State College Area School District
Ferguson Township Elementary School
Preliminary Daylight Analysis
October 1, 2009

The purpose of this analysis is to determine the daylight performance of the design as of September 2009 and to provide performance recommendations.

Mar 21st 12pm

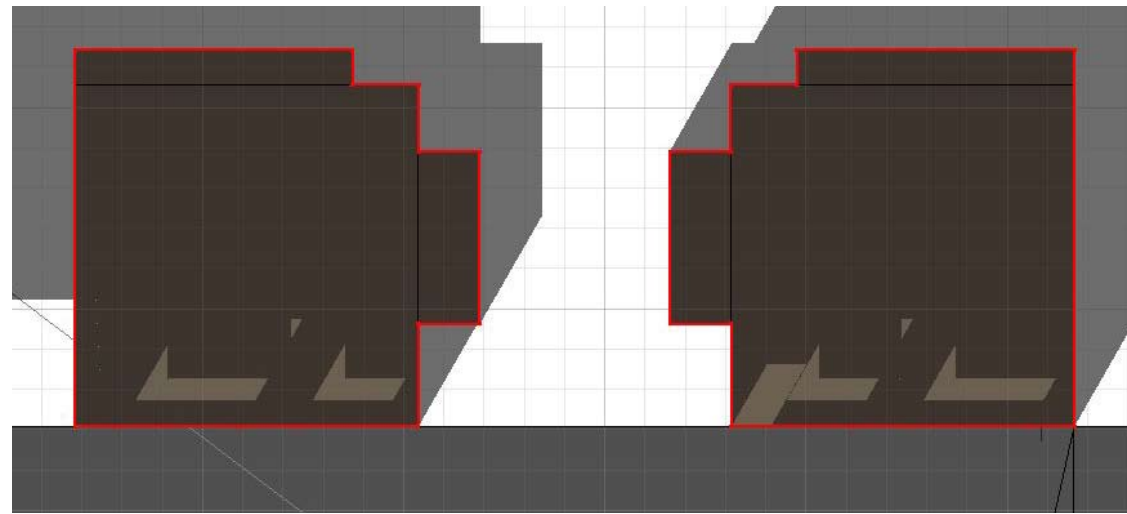
The project's orientation presents some situations that need responded to in a specific manner. The southern elevation of the classroom wing is orientated southeast. As shown in the image above, the exterior shading devices in their current size do not provide 100% shading for the classrooms.

It is recommended that the exterior shading device extend at least 1'-6" beyond the western edge of the window. Because of the orientation, the shade does not need to extend beyond the window edge on the eastern side. This is due to low sun angles.

First Floor Classrooms March 21st 12pm

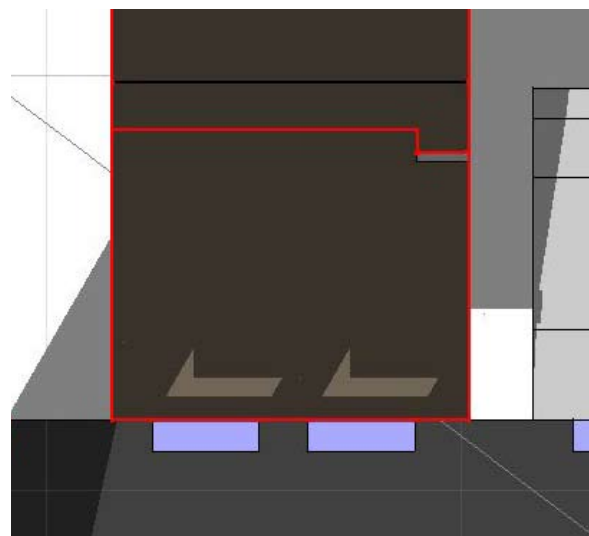
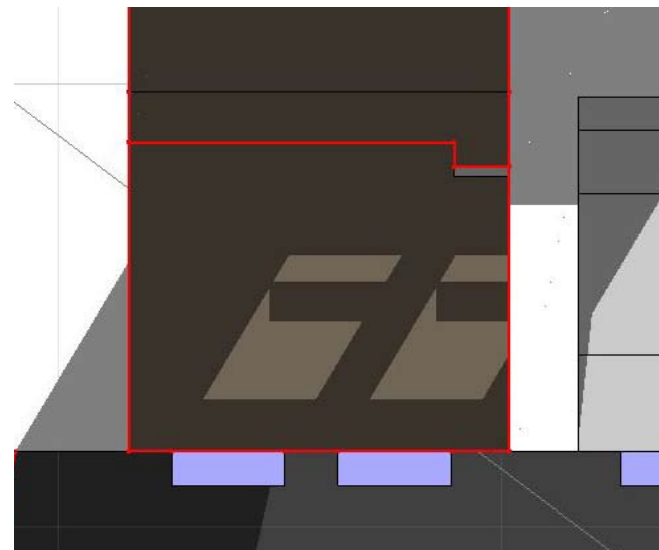
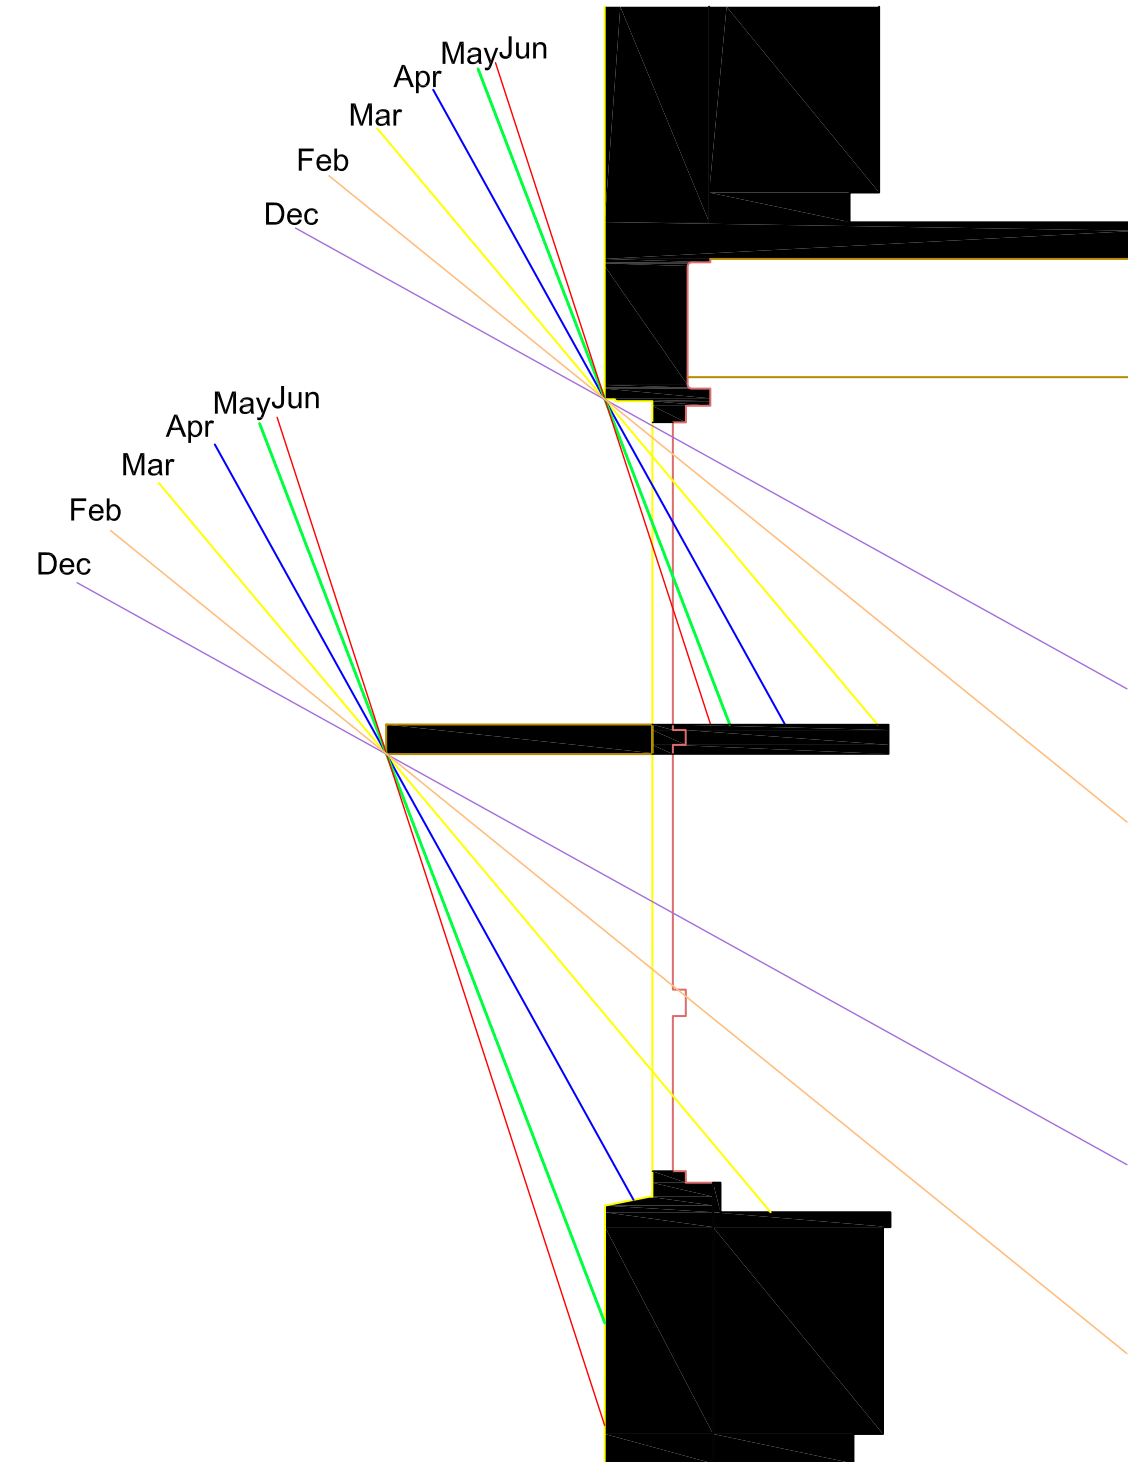
As shown in the images above, the exterior shading device needs to extend beyond the western edge of the window. Direct solar will be an issue from 8am till 10am from March to June and August to October.

In the winter months, November to February, direct solar will be an issue from 8:30am till 2pm under clear sky conditions.

Blinds will be needed in both the view and daylight windows to control the direct solar issues that will occur during clear sky conditions in the winter months.

1st Floor South Facing Classrooms

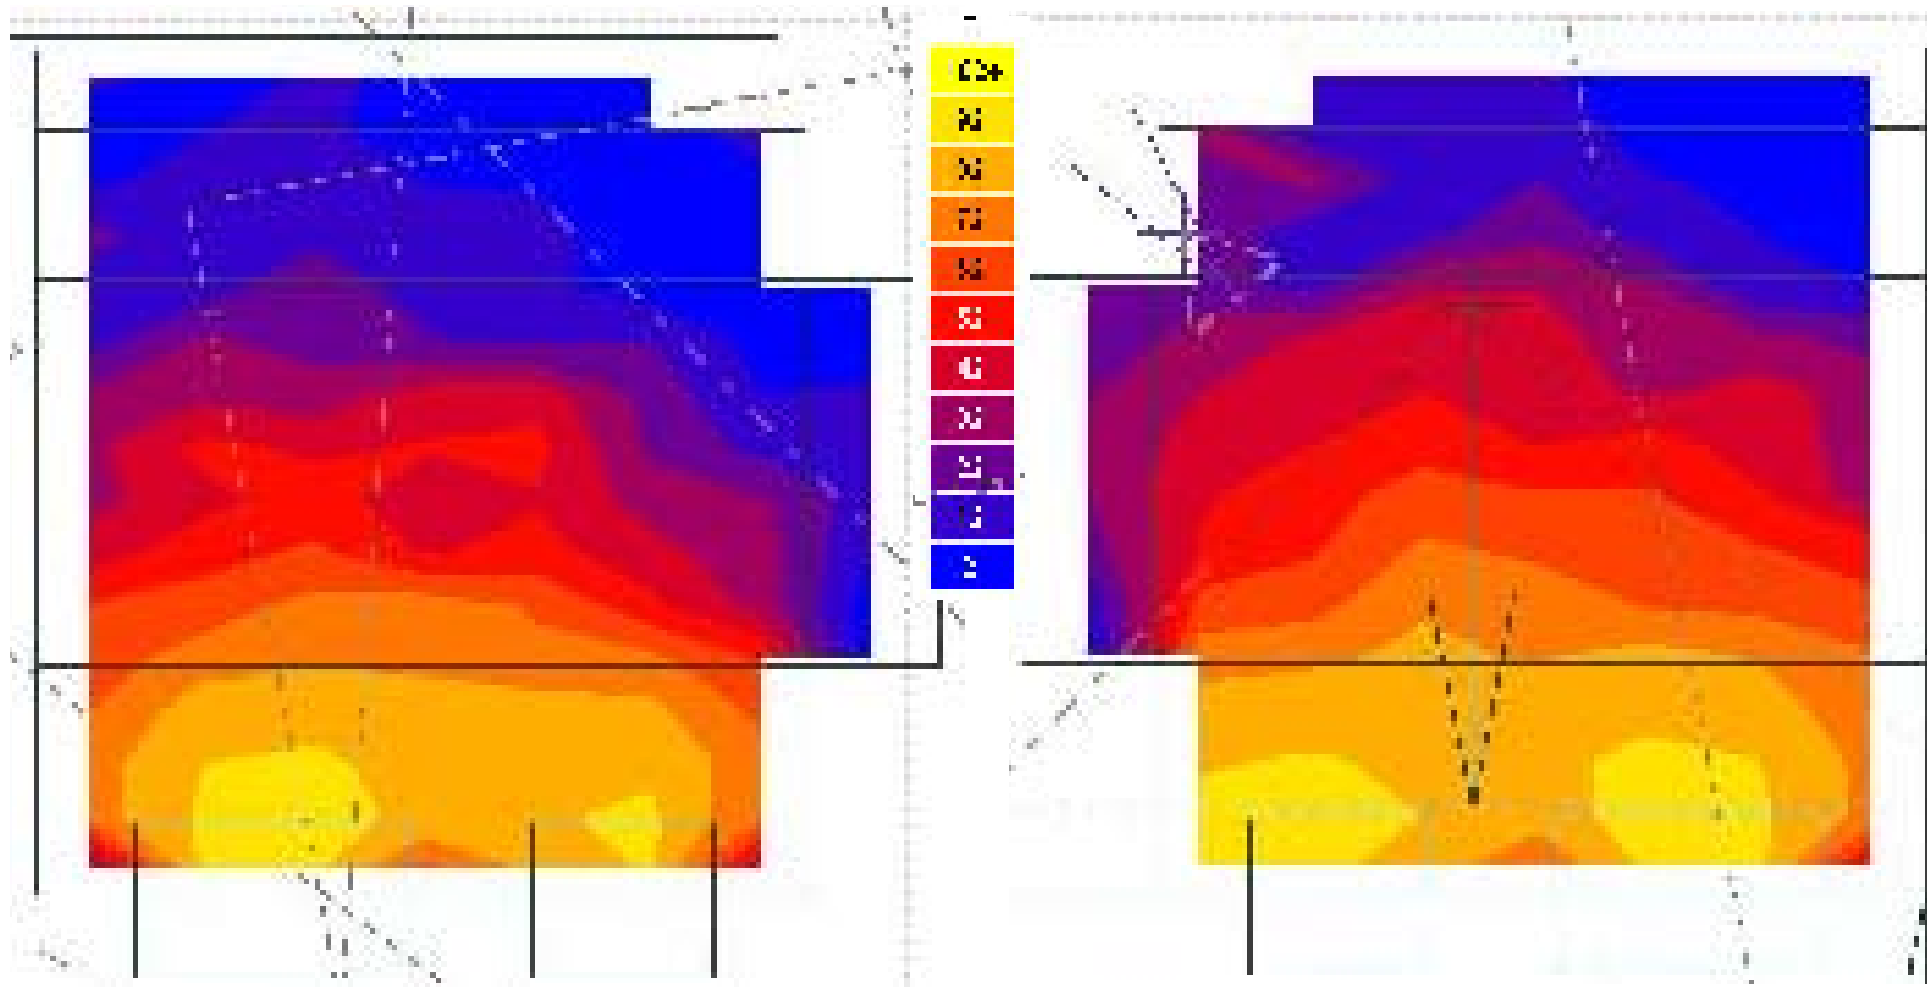
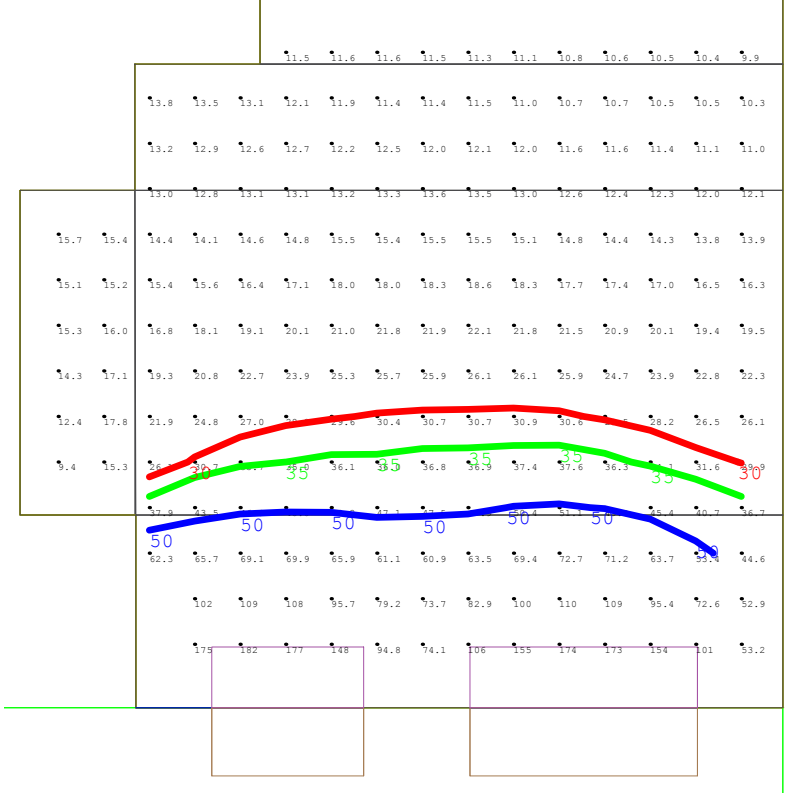
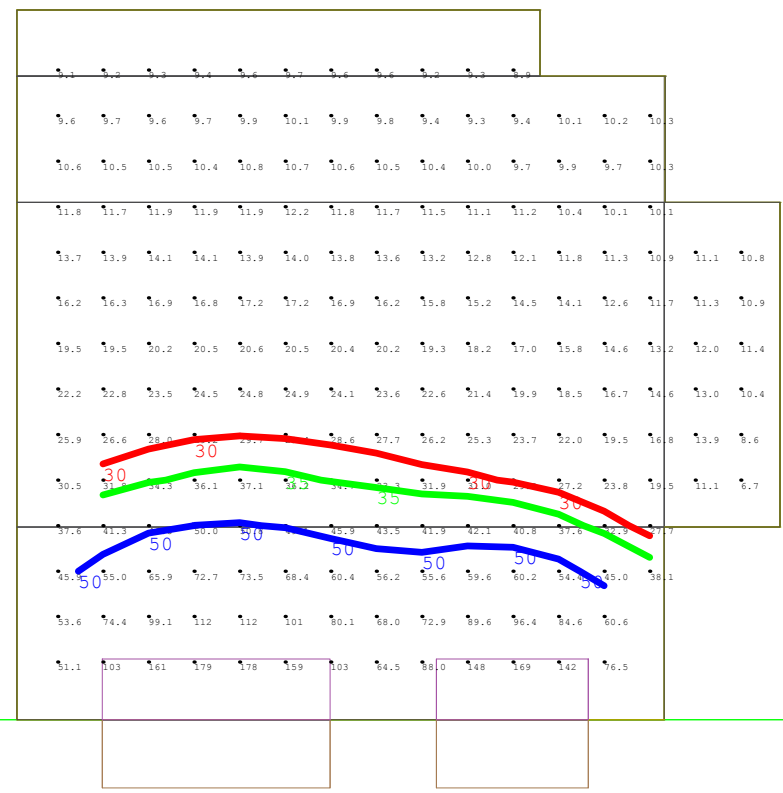
The classroom on the right was modeled with a door and the one on the left was not as a comparison. As shown in the DAR images, the targeted DAR is being met for at least 50% of the space. The bottom images are at 12pm on March 21 under overcast sky conditions, which is the worst case scenario. Those snapshot images help validate that only 50% of these spaces are meeting the target levels.

The optimal scenario is to have a view window of 60% with a SHGC around .3 and a daylight window of 70%. If for budget reasons, the glazing must be the same for each window, it is suggested that a VLT of 70%, +/- 2%, with a SHGC of around .35. A higher VLT will not hurt since the window is being shaded.

The exterior shading devices should be no less than 3'-0". The only means by which this could happen is if it is angled. Further simulations would be needed to validate performance. The shading device should have an openness value of 30-35%, see sample page at back of report.

The interior light shelf needs to be no more than 2'-8" in length from the glazing. The thinner the shelf the better, Any shelf greater than 2" in thickness should have an angled bottom surface.

Electrical lighting should be installed to compliment the daylighting. Based upon the analysis, the lighting should be parallel to the window wall. The first row should be on a sensor, the second and third rows should be at least dimmable or stepped switched.

Interior shades such as Meco should be used on both the daylight and view windows. Shades should be installed to work from the bottom up in the view window.

1st Floor North Facing Classrooms

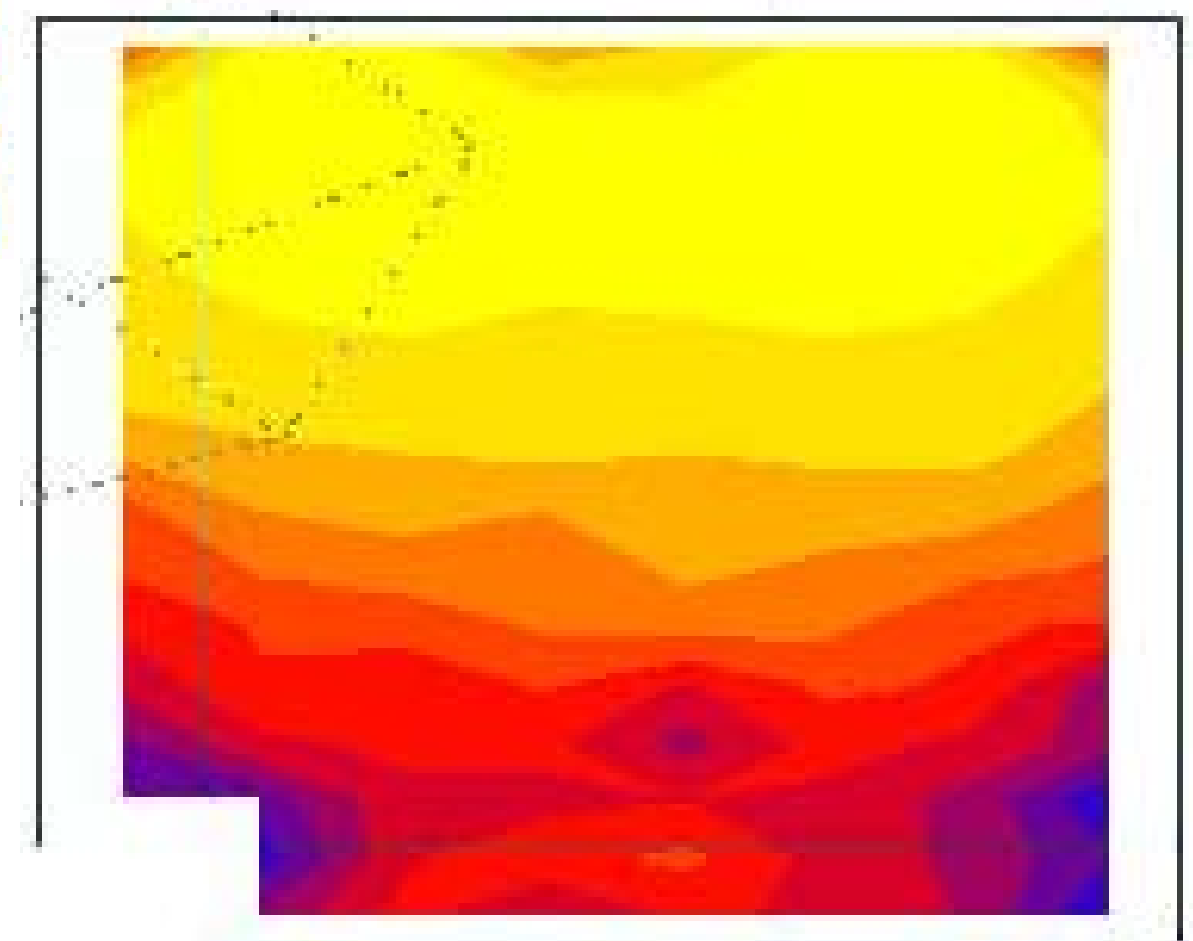
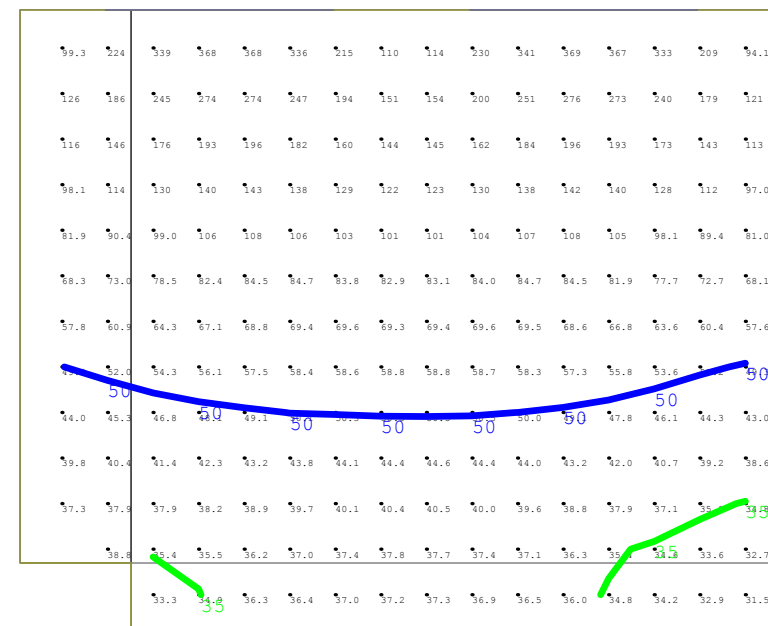
The targeted DAR is being met for almost 75% of the space. The smaller luxor image from March 21 under overcast sky conditions validates the illuminance levels.

The window to floor area could increase slightly; it is currently at 11% and could go as high as 15%. A VLT of at least 70% should be used and the SHGC should be no more than .45.

The electrical lighting should be run parallel to the window wall and each row should be stepped switched.

Shades will be necessary due to some probable glare issues.

2nd Floor South Facing Classrooms

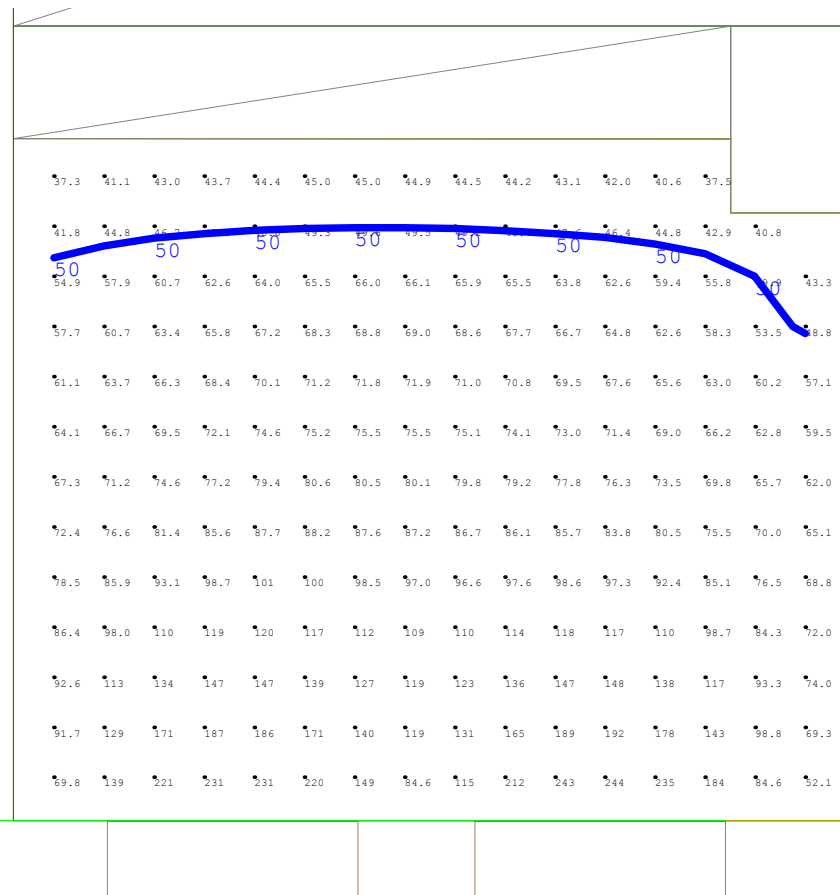
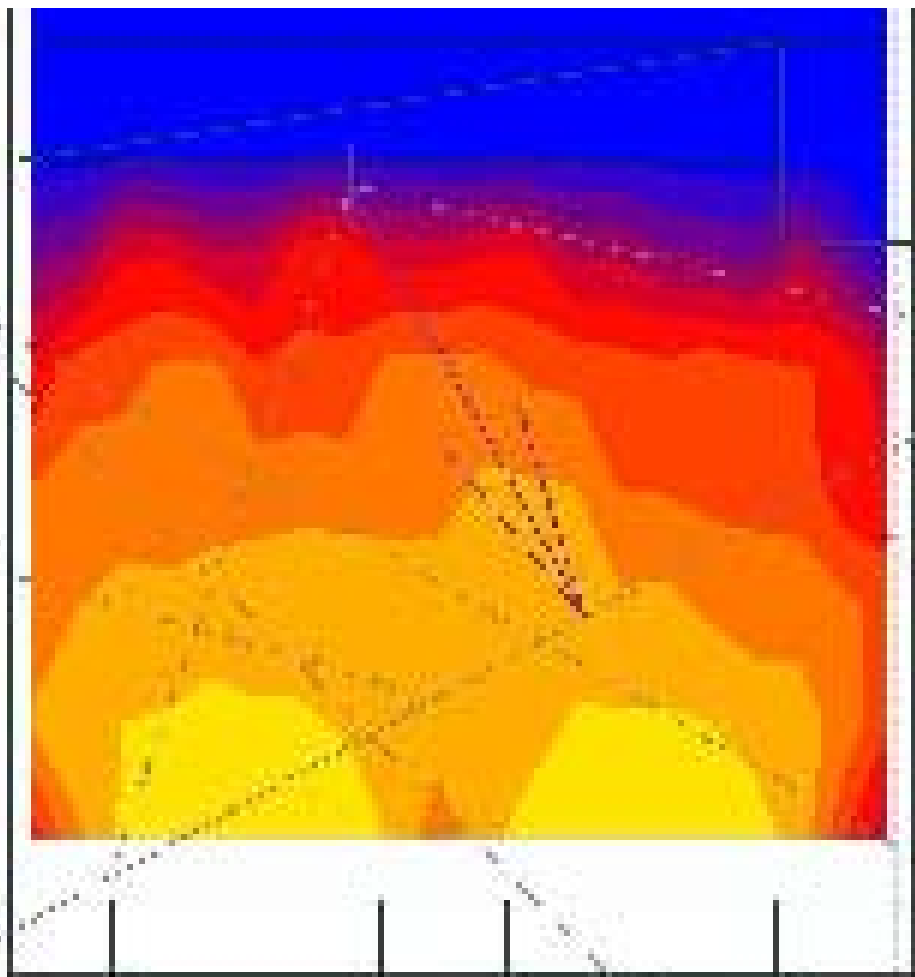
The largest portion of the space is meeting the target DAR. This due to the bilateral daylighting condition.

The optimal scenario is to have a view window of 60% with a SHGC around .3 and a daylight window of 70%. If for budget reasons, the glazing must be the same for each window, it is suggested that a VLT of 70%, +/- 2%, with a SHGC of around .35. A higher VLT will not hurt since the window is being shaded.

The exterior shading devices should be no less than 3'-0". The only means by which this could happen is if it is angled. Further simulations would be needed to validate performance. The shading device should have an openness value of 30-35%, see sample page at back of report.

Electrical lighting should be installed to compliment the daylighting. Based upon the analysis and a bilateral daylighting condition it would be feasible to have the first two rows dimmable with a daylight sensor and the third row be stepped switched.

Interior shades such as Mecos should be used and installed to work from the top down.
